HOAX BASS 25

#1.3b (cm)

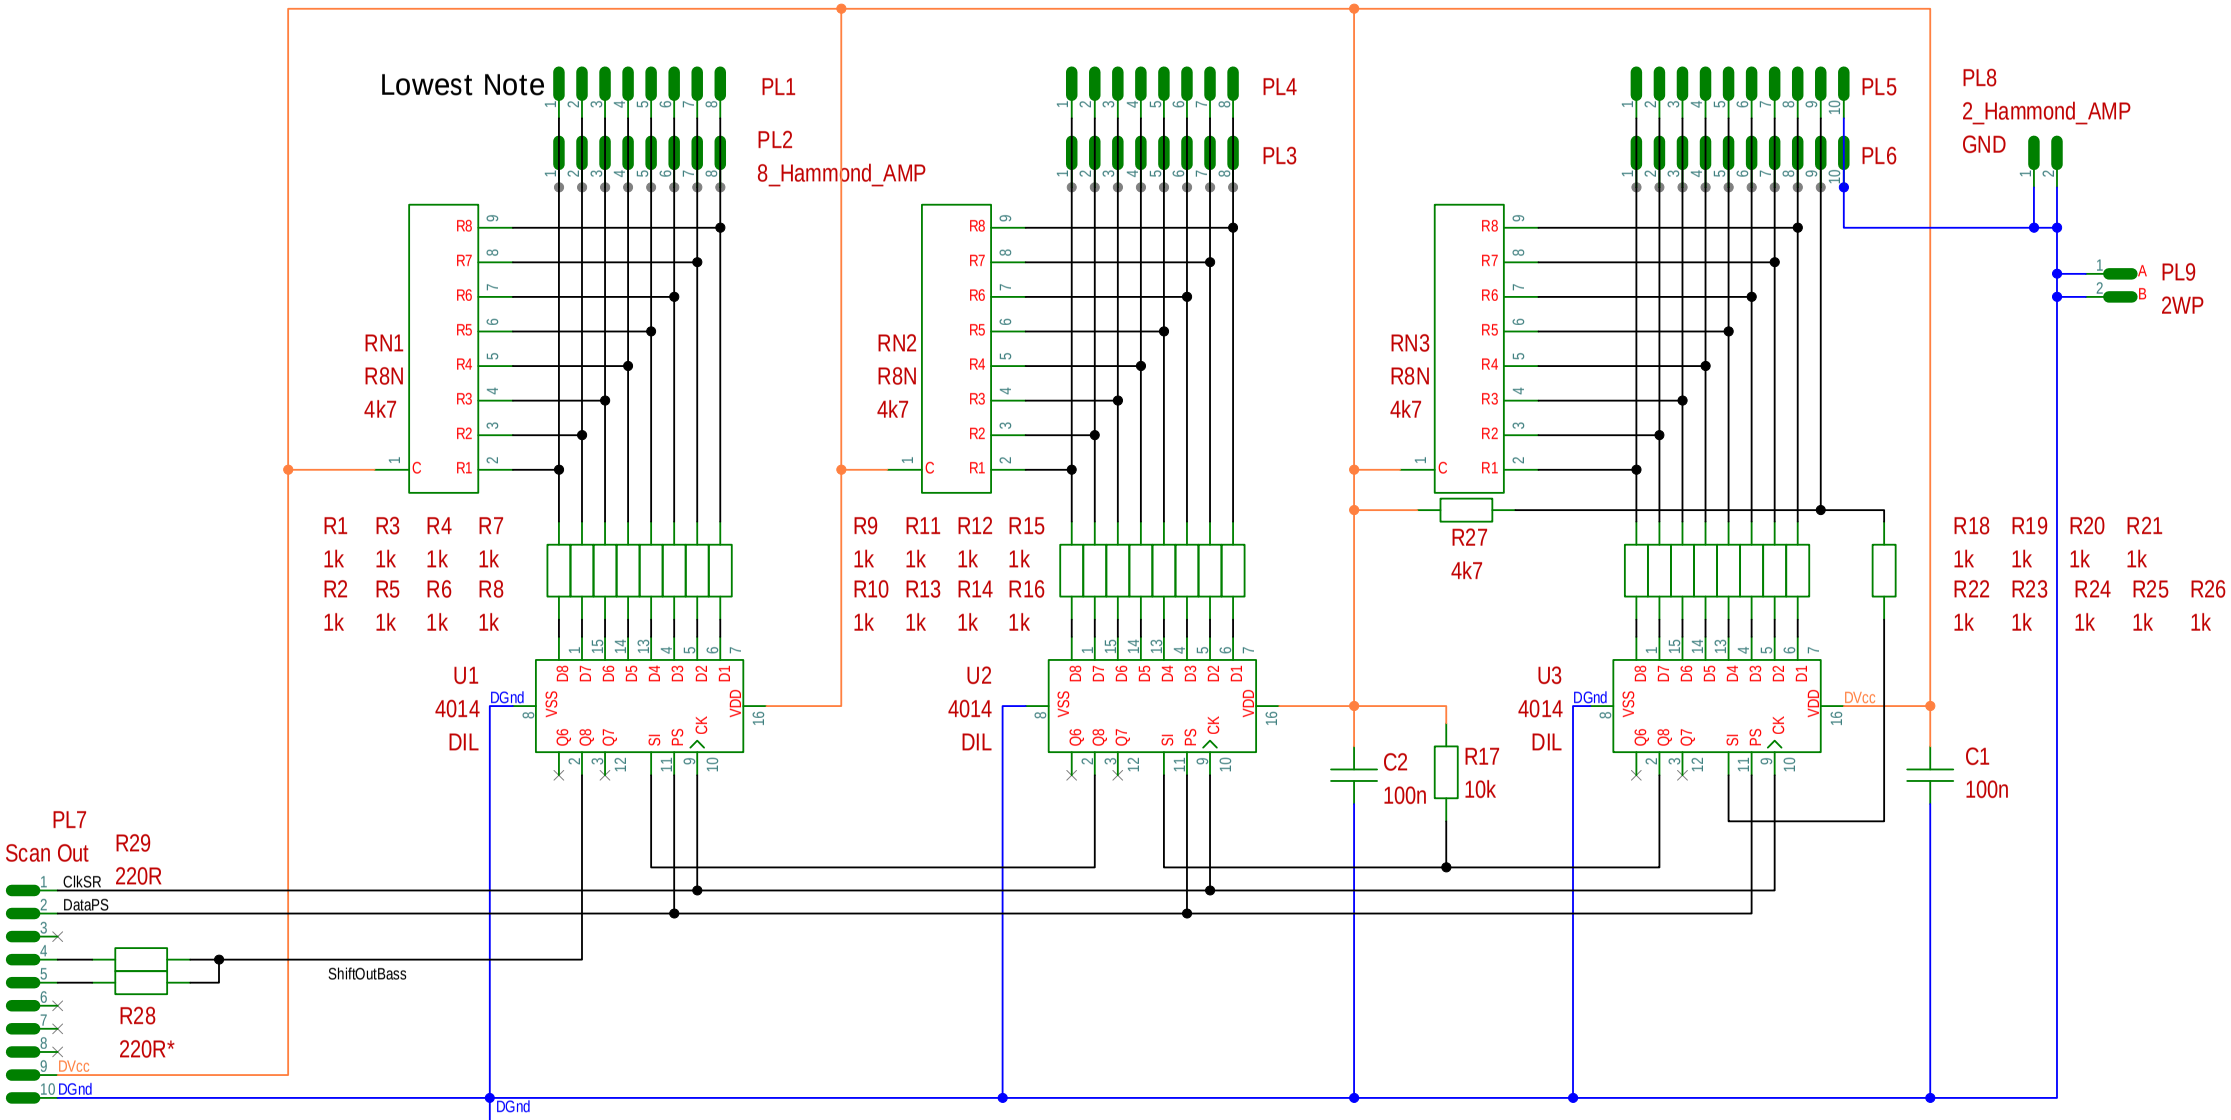
use either
R29 for OrganScan61 daisy chain
or
R28 for FatarScan2, Scan-16, Scan-INLINE

from #1.2: changed connection of R28, R29
for OrganScan61 compatibility

omit U3/RN3 and R18 to R26
for 13-note pedal
